Model Difference Letter

Changyou Technology (Zhejiang) Co., Ltd., is applying for FCC ID: 2BEKX-SYW for the model: TO-Q-SY2-JWT. The PCB layout is as follows:

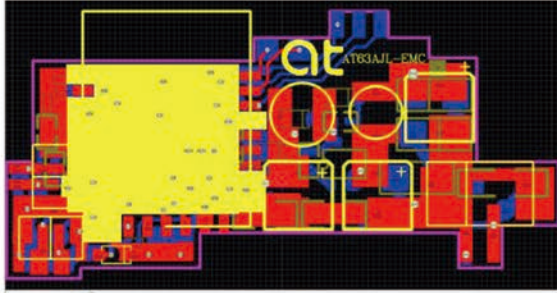
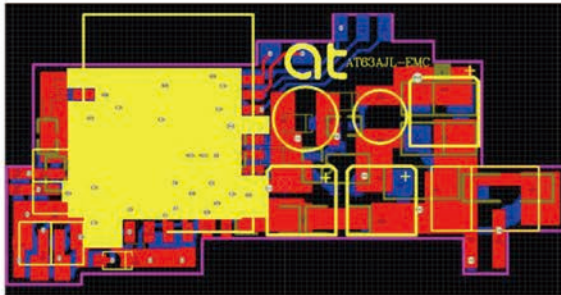
Differences: TO-Q-SY1-JWT is based on TO-Q-SY2-JWT but with the removal of the temperature sensing resistor (100K ohm NTC).
